R66 SERVICE BULLETIN SB-17A

SUBJECT: F642-1 Shaft Replacement

ROTORCRAFT AFFECTED: R66 Helicopters equipped with F642-1 revision C and prior shaft weldments (originally installed on R66 S/N 0001 thru 0172), as well as spare F642-1 revision C and prior shaft weldments.

FIGURE 1

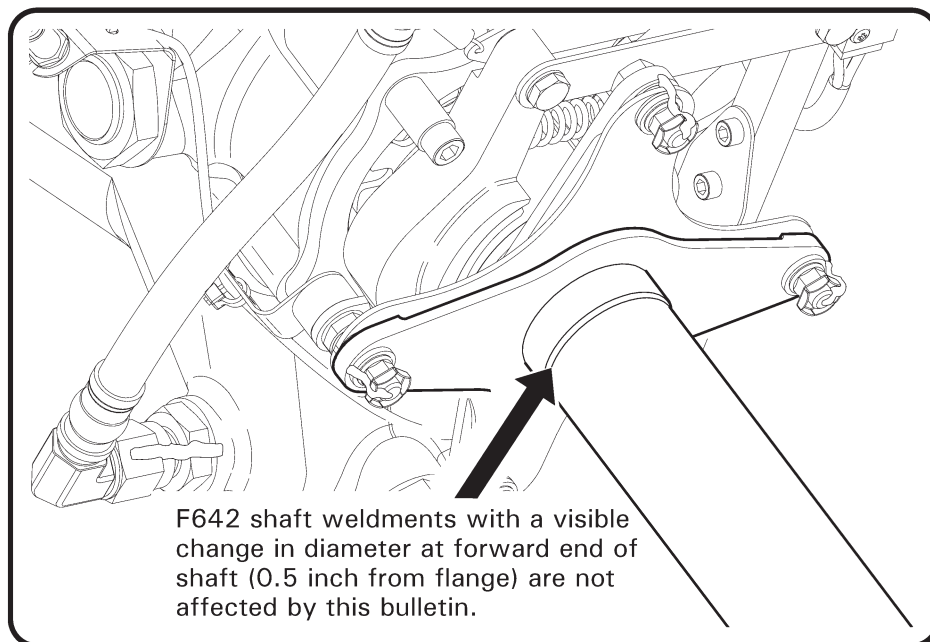
1. Refer to Figure 1. Visually inspect forward end of installed F642 shaft weldment for a visible change in diameter. Shafts with a change in diameter at location shown are revision D or subsequent and therefore are not affected by this bulletin; no further action is required.
2. If installed shaft does not have a change in diameter at location shown, remove shaft per R66 Maintenance Manual (MM) § 63-10, order one R9535 kit from [RHC Customer Service](#), and install kit per MM § 63-10. (For kits which contain F642-7 shaft, use NAS6604-5 bolts to attach shaft to flex plates.)
3. Balance shaft per MM § 18-70 in conjunction with chart in Figure 2.
4. Make appropriate maintenance record entries. No change to helicopter weight and balance.
